UNITED STATES PATENT AND TRADEMARK OFFICE

10/575,858

Office Action Summary	Application No. 10/575,858	Applicant(s) LEE, SANG RYUL	
	Examiner Quang T. Van	Art Unit 3742

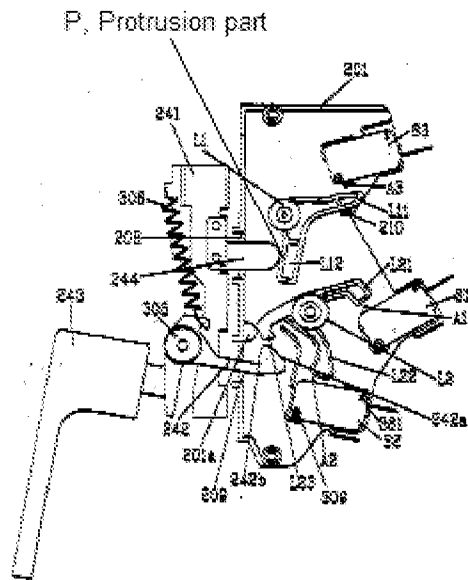
4. Claims 1, 5-7, 9-12 are rejected under 35 U.S.C. 102(e) as being anticipated by Lee et al (US 2004/0182856). Lee discloses, figures 2-3, door assembly for microwave with oven comprising a cavity (20) into which food is loaded; a door (14) for opening/closing a front side of the cavity; at least one latch (142) formed at an inner side of the door (14); a latch board (101) for supporting the latches when the latch is inserted therein; a monitor switch (S3) and a circuit switch (S1, S2), provided on the latch board (101), for performing on/off operation to control the microwave oven; a first lever (L2) having one end contacting with the monitor switch (Par. 0022) and the other end contacting with the latch, the first lever (L2) rotating to turn on/off the monitor

switch; a second lever (L1) having one end contacting with the circuit switch (S2) and the other end contacting with the latch (142a), the second lever (L1) rotating to turn on/off the circuit switch; and a protrusion part (P1, Figure below) formed at a periphery of the first lever (L2) and protruded from a portion with which the latch (142) comes in contact, such that if the latch is inserted, the monitor switch (S3) operates before the circuit switch (S1), and if the latch is released, the monitor switch (S3) operates after the circuit switch (S1).

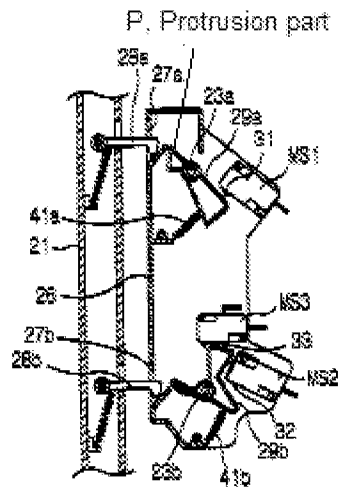
6. Claims 12-15 are rejected under 35 U.S.C. 102(a) as being anticipated by Kim et al (US 6,521,875). Kim discloses, figure 2, microwave oven having conducting member comprising a monitor switch (MS1) including a monitor button (31) operated by a first lever (29a), an internal contact point of the monitor switch being on/off by the monitor button (31); a circuit switch (MS2) including a circuit button (32) operated by a second lever (29b), an internal contact point of the circuit switch (MS3) being on/off by the circuit button (33); a first lever hinge for hingedly fixing the first lever (29a); a second

lever hinge for hingedly fixing the second lever (29b); and a protrusion part (P, figure below) protruded from one side of the first lever (29a) in an inserting direction of a latch (28a).
